TO: Historical Commission
FROM: Sean Gallegos, Senior Planner
SUBJECT: H22-0002 – 725 University Avenue

Recommend approval of an addition and minor exterior alterations to a Historic Resource property subject to the listed findings

725 University Avenue Garage Alterations
Los Altos, CA
Secretary of the Interior's Standards Project Analysis

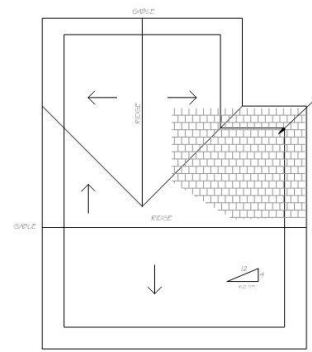
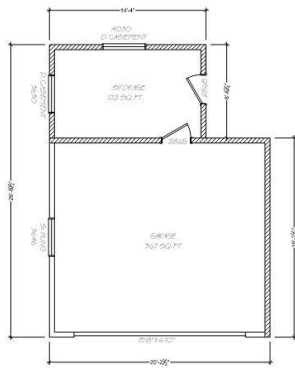
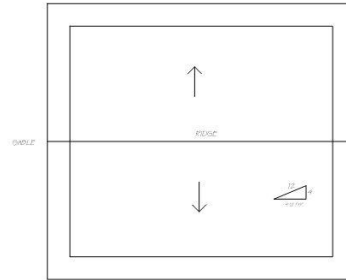
Response: The scope of this project is minimal involving moving two walls of a roughly square garage out by a maximum of 2'-4". Rather than differentiating, the new work from the old, it seems more appropriate, because the scale is so small, to rebuild the new walls to match the existing original walls.

The garage alterations include minor changes to the roof and elevations that alter but maintain the mass and general appearance of the structure. The proposed alterations are only visible from Lee Street and the alley and will not compromise the historic character of the house or overall property. The garage will be clad in painted wood shingles with an asphalt roof shingle matching that of the house. The double hung and casement windows will be painted wood. The new Lee Street garage door while slightly wider, will follow the same design as the existing door. (Figures 9 through 12)

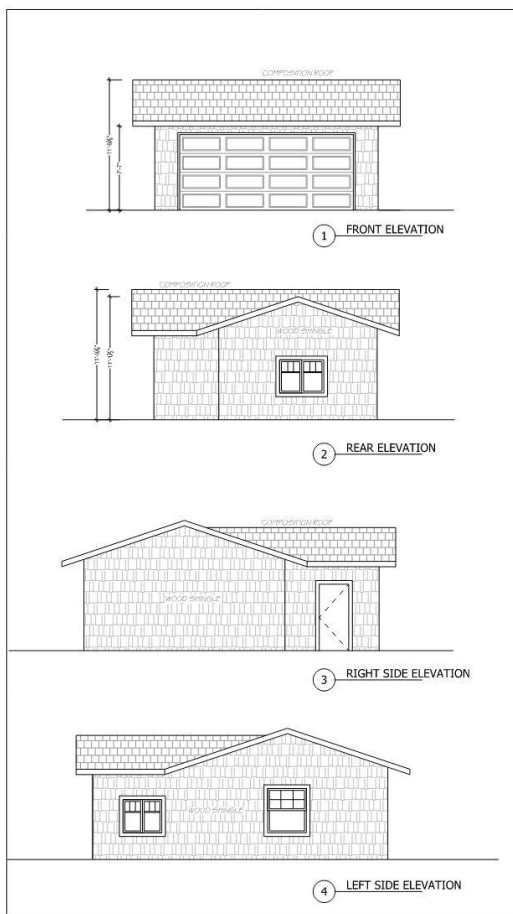
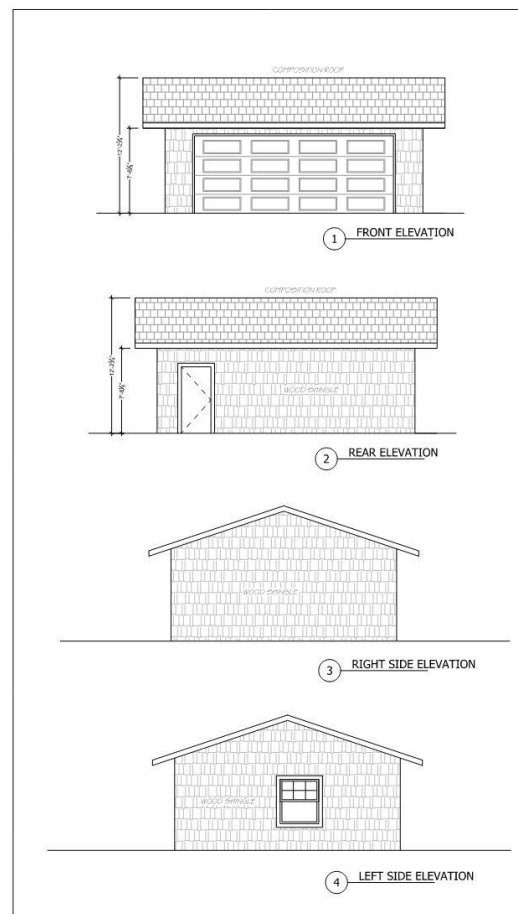
The accessory structure alterations include minor changes to the roof and elevations that alter but maintain the mass and general appearance of the structure. The proposed alterations are only visible from Lee Street and the alley and will not compromise the historic character of the house or overall property. The garage will be clad in painted wood shingles with an asphalt roof shingle matching that of the house. The double hung and casement windows will be painted wood. The new Lee Street garage door while slightly wider, will follow the same design as the existing door.

Response: While the garage is being slightly enlarged, it is an extremely simple ancillary building. The east wall has already been compromised by the non-historic addition. The south wall will be reconstructed only 2'-4" to the south of the original wall using the same framing techniques with the same wood shingle cladding.

EXISTING GARAGE IMAGES

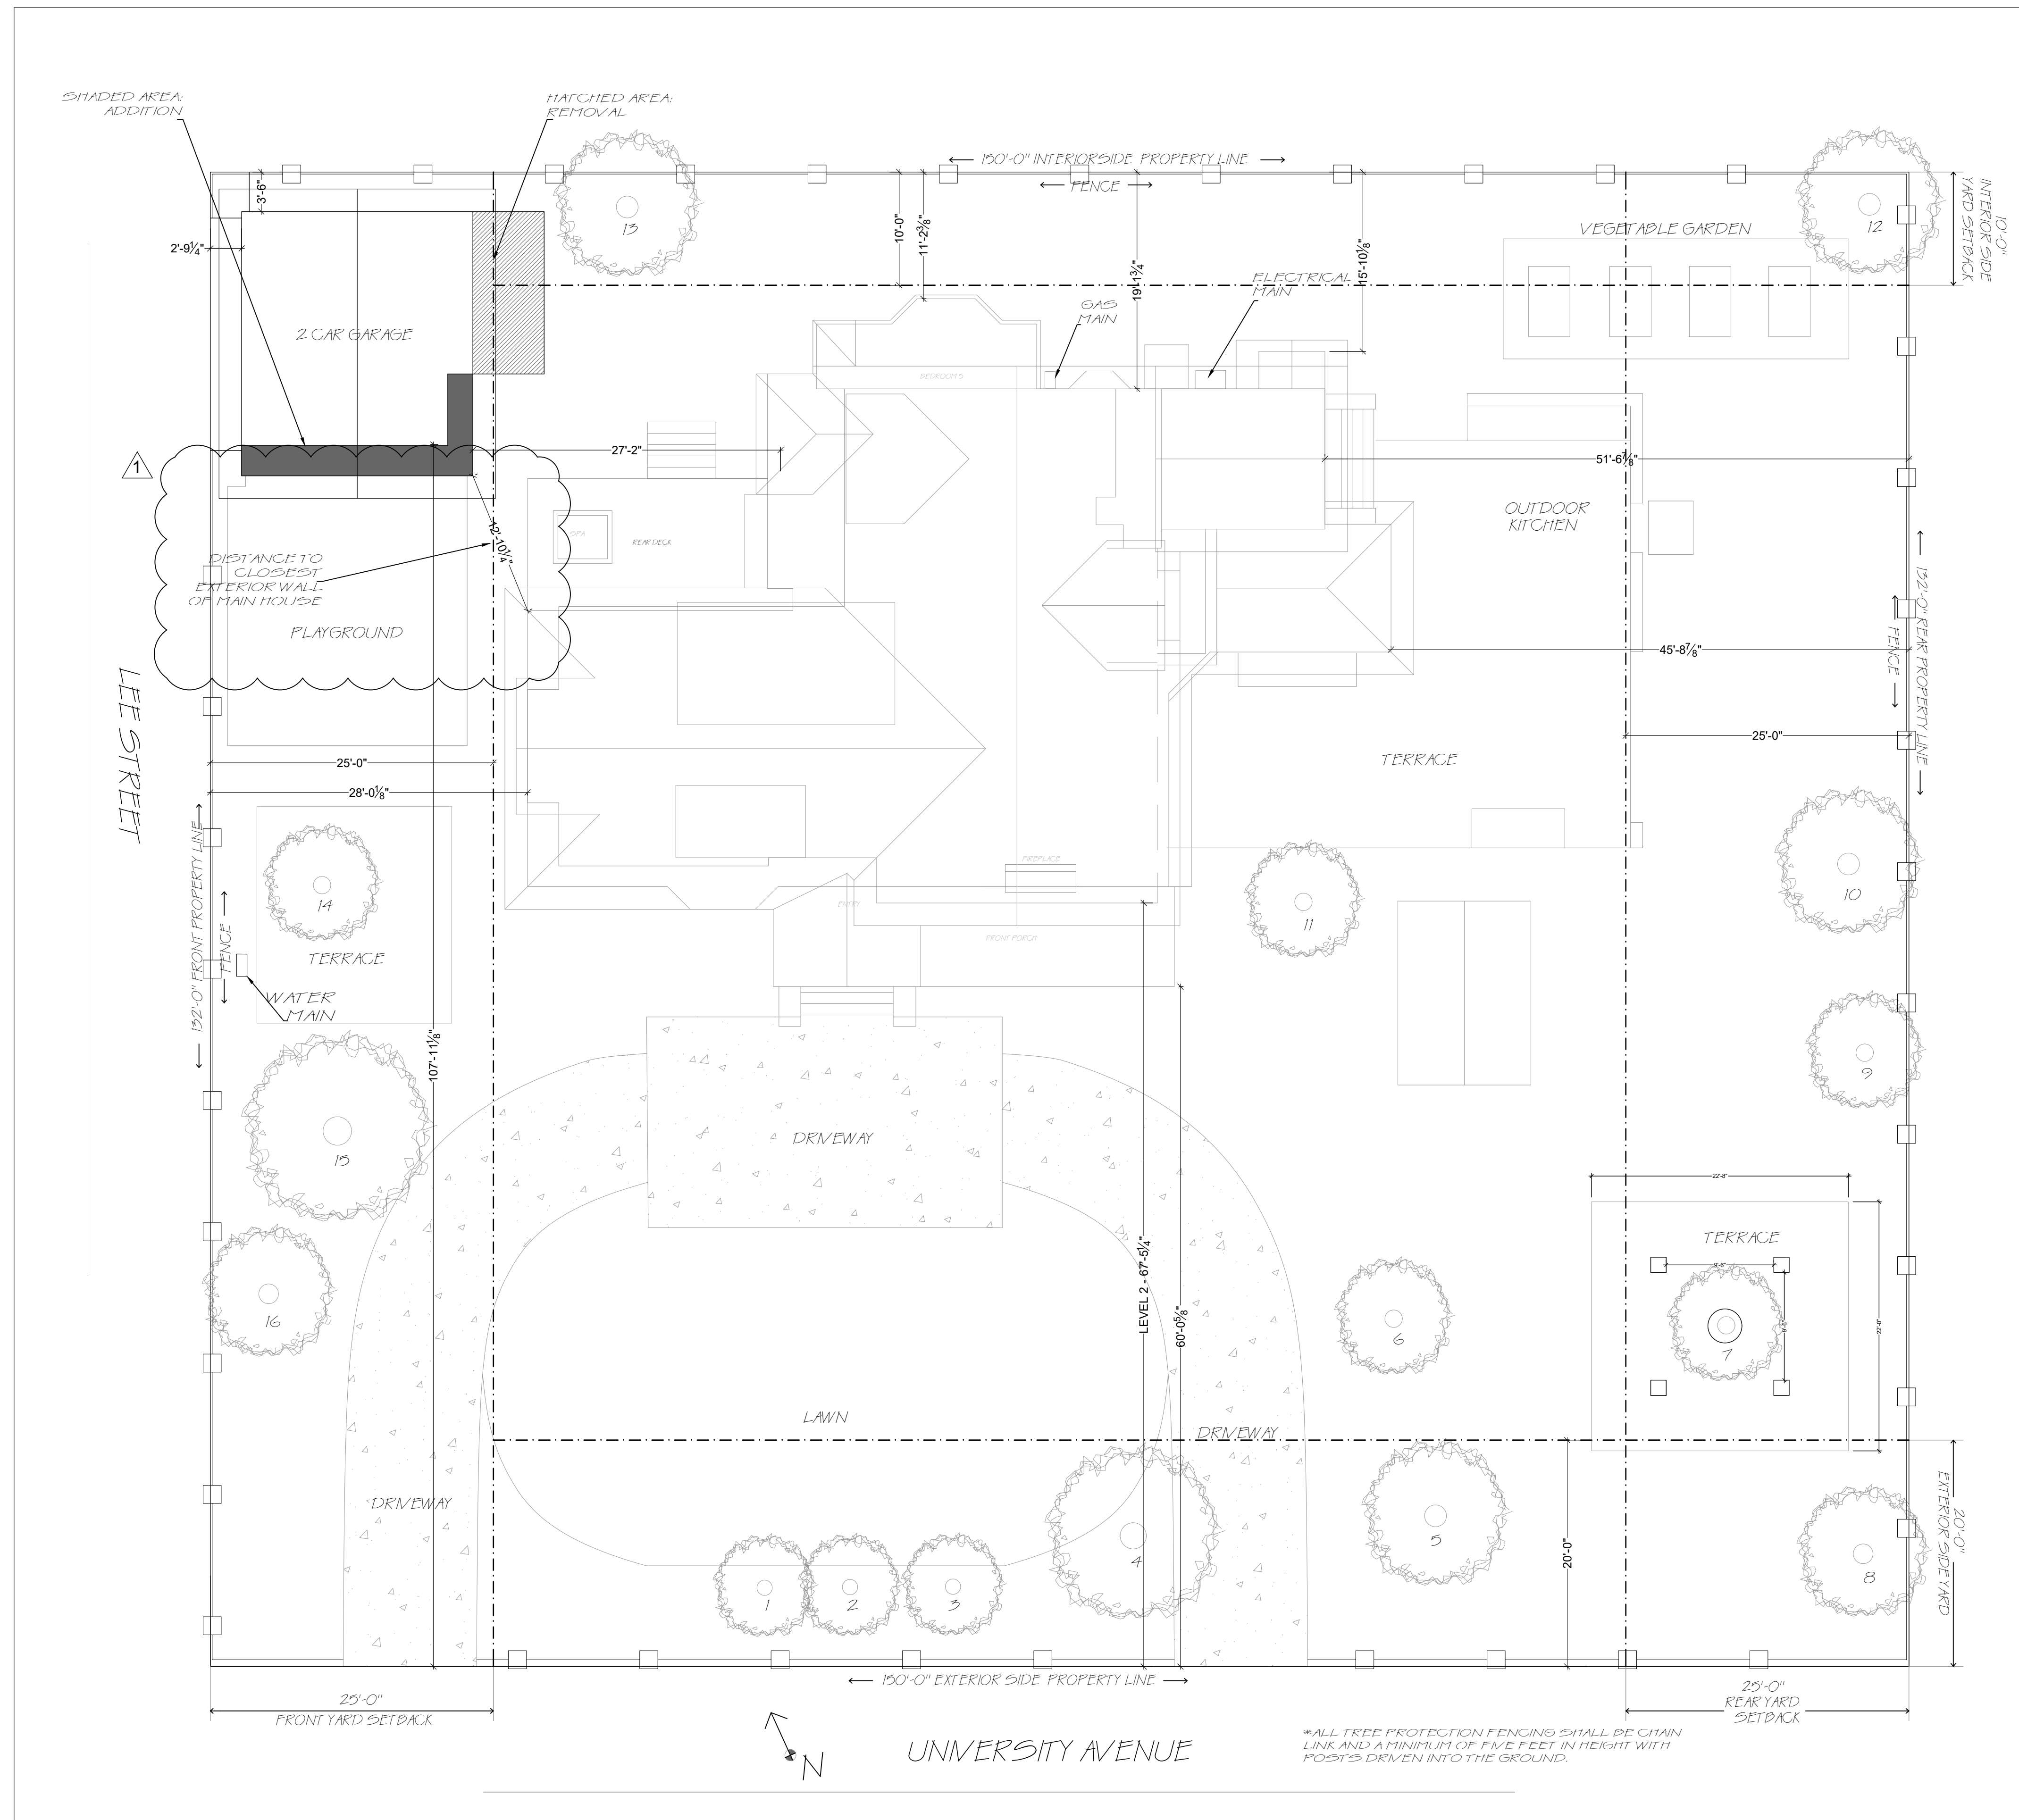
Please Note: The rendering inadvertently leaves out the exposed roof rafters at the bottom of the roof. They will still be there, maintaining the style of the garage as it is today.
